Further Advice Response

To	Frank Developments Pty Ltd & Signature Property Partners	Date	1 July 2026
Prepared by	Casey Schackow, Velocity, Director	Approved by	Harj Singh, Traffic Engineering Advisor (RPEQ 22364)
Location	33 Oxlade Drive, New Farm		
Status	Final	Attachments	Appendix A: Further Advice Appendix B: Development Plans Appendix C: Swept Path Assessment

Velocity has been commissioned by Frank Developments Pty Ltd & Signature Property Partners to provide traffic and transport advice in response to the items within the Further Advice (FA), for the Minor Change Application (MCA) of the site located at 33 Oxlade Drive, New Farm.

Title BASEMENT B1 FLOOR PLAN

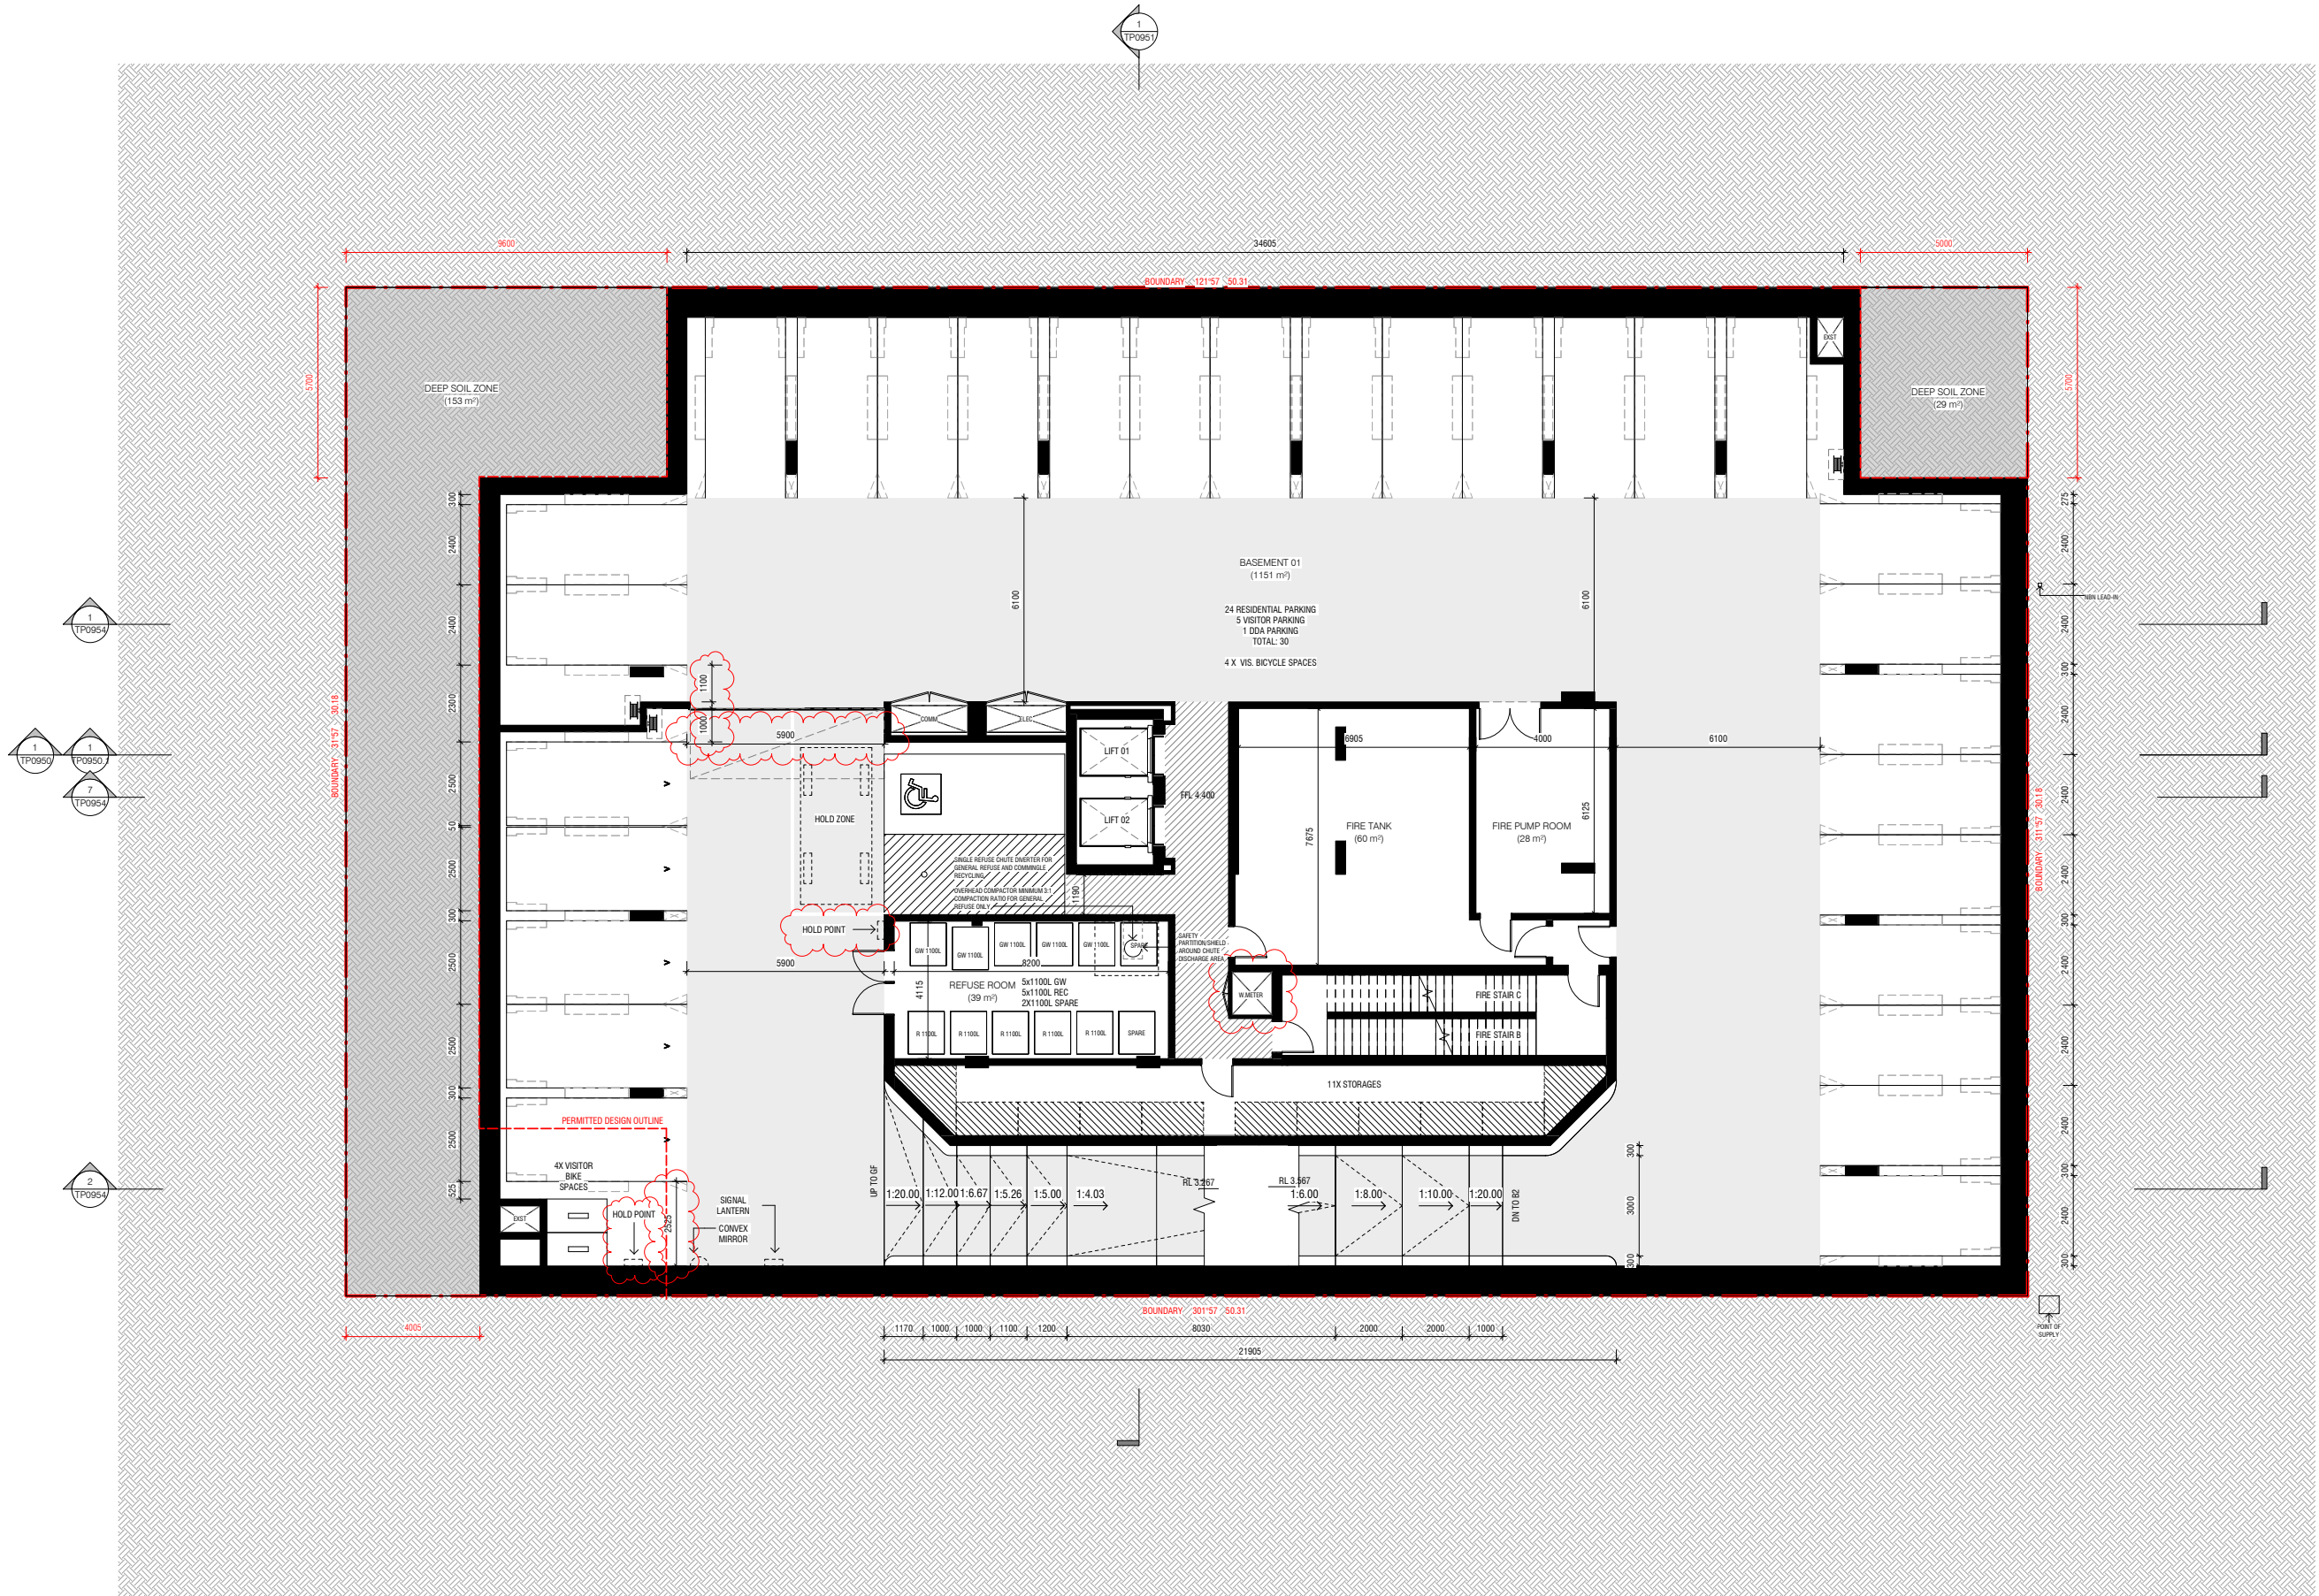
- b. Provide justification for the reduced aisle width and end treatment depth on Basement B1. Demonstrate that visitors can safely enter/exit the spaces at the base of the ramp and adjacent to the security screen door via swept path analysis

The Basement B1 visitor parking area has been reviewed against AS2890.1.

The visitor parking spaces are proposed as User Class 2 spaces. For 90-degree User Class 2 parking, AS2890.1 requires a minimum aisle width of 5.8m, with a 1m aisle extension at the end of a blind aisle.

The proposed visitor parking area provides a minimum aisle width of 5.9m throughout, which exceeds the AS2890.1 minimum requirement. A 1m aisle extension is provided

beyond the final visitor parking space, with 1.3m provided beyond the PWD space adjacent to the security screen door.

On this basis, the Basement B1 visitor parking aisle width and end treatments achieve direct compliance with AS2890.1. As the layout satisfies the applicable AS2890.1 dimensional requirements, a swept path assessment is not considered necessary nor required to demonstrate compliance for these parking manoeuvres.

1 BASEMENT SECTION - NORTH TO SOUTH 01
TP0954 SCALE 1 : 100

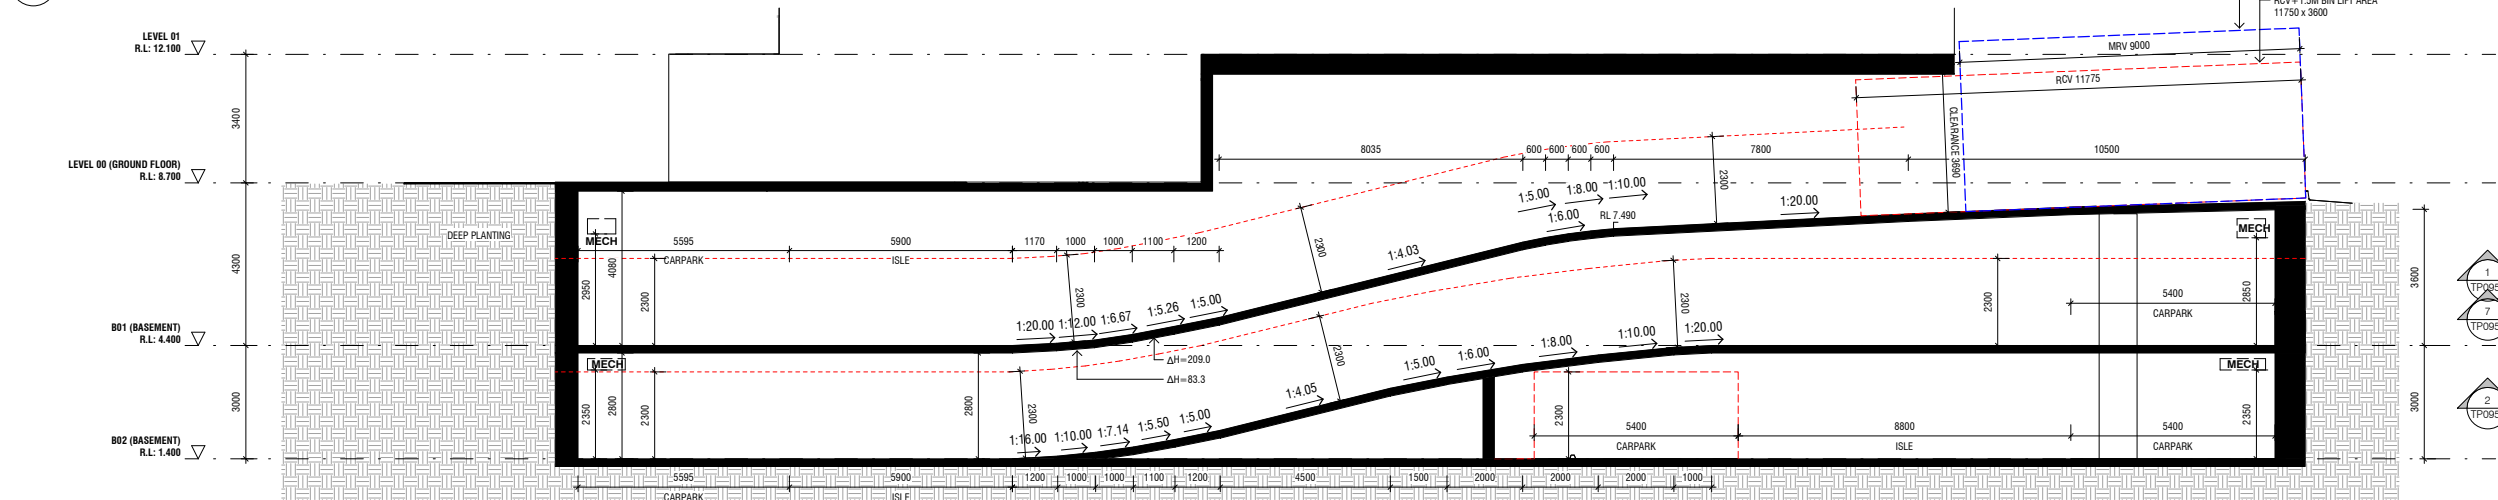
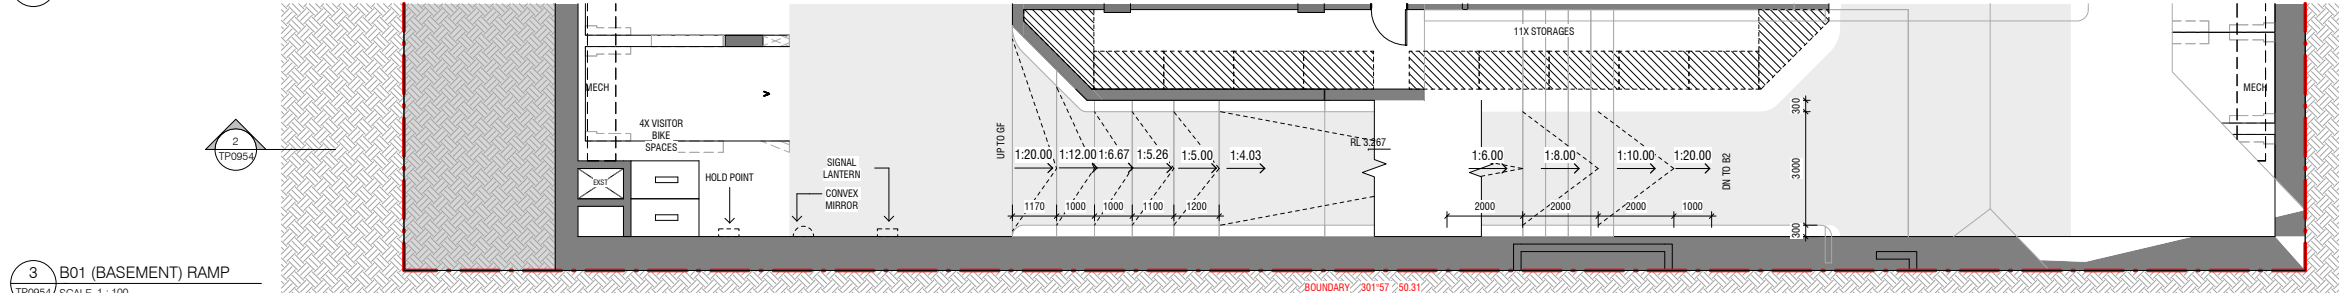
- c. Confirm the proposed vertical clearance on Level 00 and Basement B1 and clearly demonstrate this on sectional plans. Ensure that where utilities or services are suspended from the ceiling adequate clearance is maintained and also shown on sectional plans.

Sectional plans have been prepared by Kennon to confirm the proposed vertical clearance throughout the car park, including the ramp sections and areas where services or utilities are suspended from the ceiling.

The sections identify the lowest protrusions from mechanical ducting and other suspended services throughout the relevant car park levels. On Basement B1, the lowest service protrusion is 2.85m above finished floor level, which exceeds the minimum 2.3m headroom requirement and the 2.5m clearance requirement for the PWD parking space.

On Basement B2, the lowest typical service protrusion below mechanical ducting is 2.35m above finished floor level, which exceeds the minimum 2.3m headroom requirement. The only lower areas are the two parking spaces located below the ramp at the end of the Basement B2 aisle, where the clearance reduces to 2.3m at the end of the spaces as the ramp structure descends overhead. This achieves the minimum required clearance.

The ramp vehicle travel paths also maintain vertical clearance greater than 2.3m, with the lowest point within the ramp sections being approximately 2.8m. Accordingly, the ramps exceed the minimum headroom requirement.

On this basis, the proposed vertical clearances throughout the car park, including the ramp sections and areas affected by suspended services, comply with the headroom requirements of both BCC TAPS and AS2890.1.

3 B01 (BASEMENT) RAMP
TP0954 SCALE 1 : 100

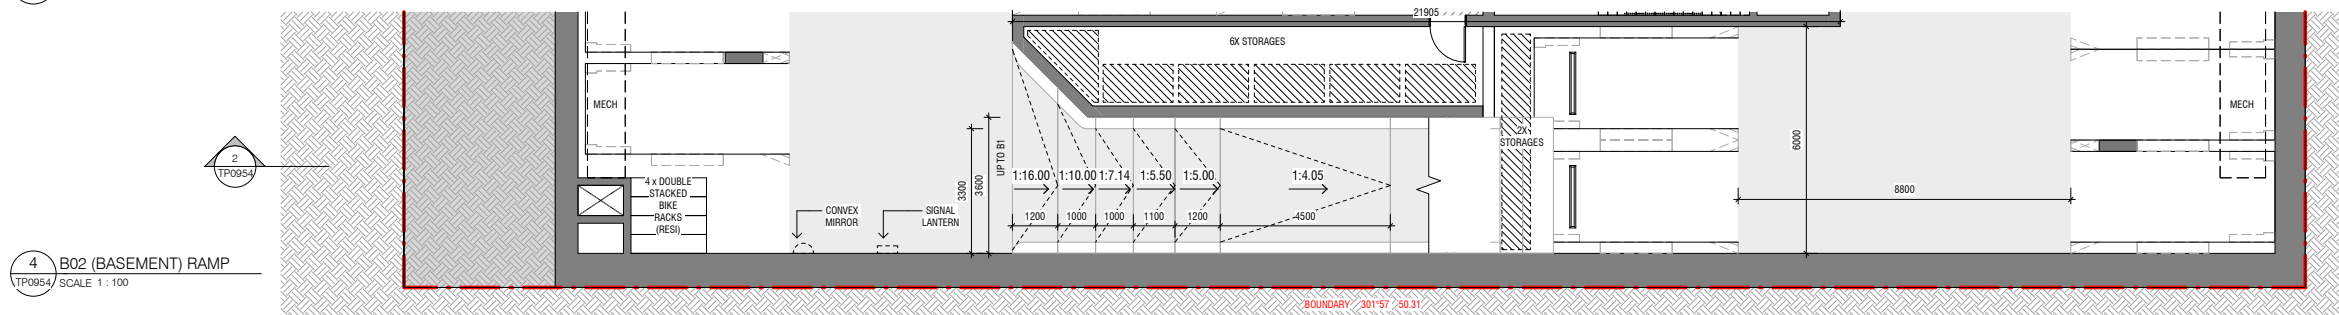
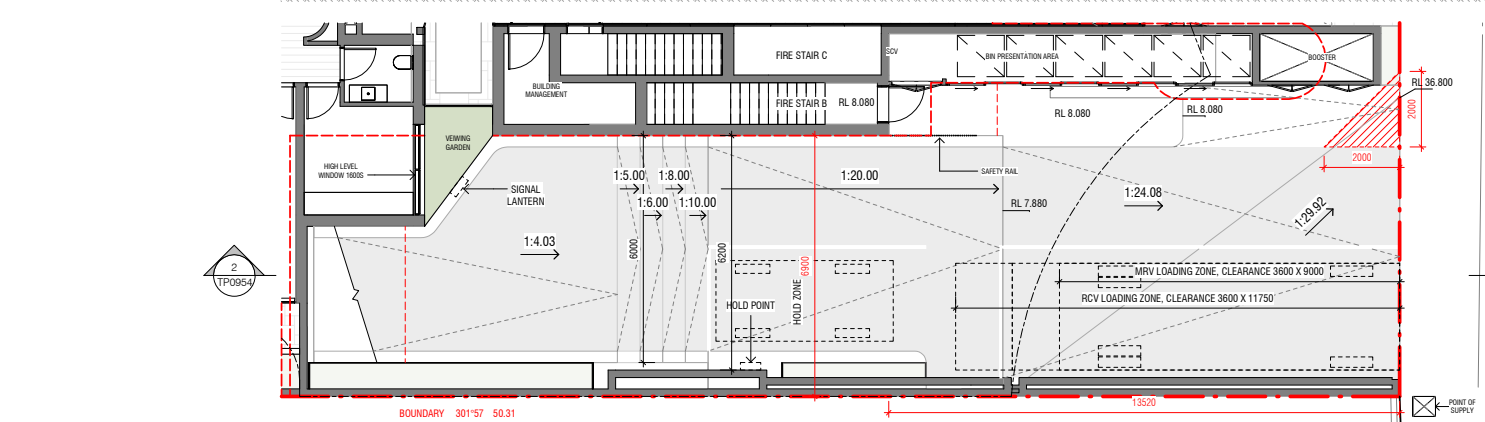
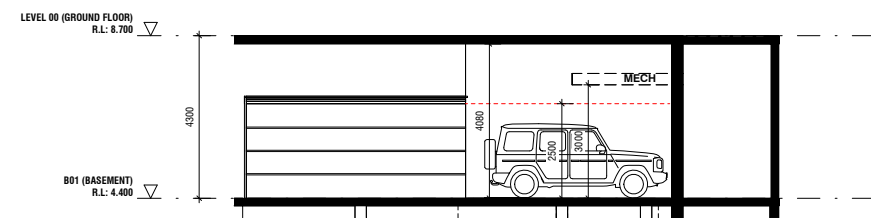
- a. Provide justification for the reduced ramp width at Level 00, Basement B1 and Basement B2. Demonstrate how cyclist and vehicle safety are to be managed.

The proposed ramp geometry and layout achieve direct compliance with BCC TAPS and AS2890.1.

The MCA introduces a signal-controlled one-way ramp arrangement between Level 00, Basement B1 and Basement B2. As each ramp section is less than 20m in length and functions as a one-lane, one-way ramp, the applicable minimum width is 3m, with an additional 300mm clearance to walls or obstructions on each side. This requires a total clear width of 3.6m.

The proposed ramp arrangement provides a minimum 3.6m width at Level 00, Basement B1 and Basement B2. The ramp edges are also provided with 150mm high by 300mm wide kerbs, consistent with the required side clearance treatment. On this basis, the ramp geometry, width and edge treatment achieve direct compliance with the relevant BCC TAPS and AS2890.1 requirements.

To support safe cyclist ingress and egress through the proposed one-way ramp arrangement and uphold pedestrian safety, the development plans have been updated to include cyclist push buttons at the relevant ramp hold points. A cyclist push button is proposed adjacent to the Ground Level hold point, with further cyclist push buttons proposed at Basement B1 adjacent the hold point for resident cyclists and one adjacent the visitor bicycle area for visitors.

The proposed push buttons will allow cyclists to initiate the green-light sequence before using the ramp. During this sequence, opposing vehicles will be held on red, allowing cyclists to travel through the one-way ramp section without opposing vehicle conflict. This arrangement is considered safe and appropriate on a performance basis.
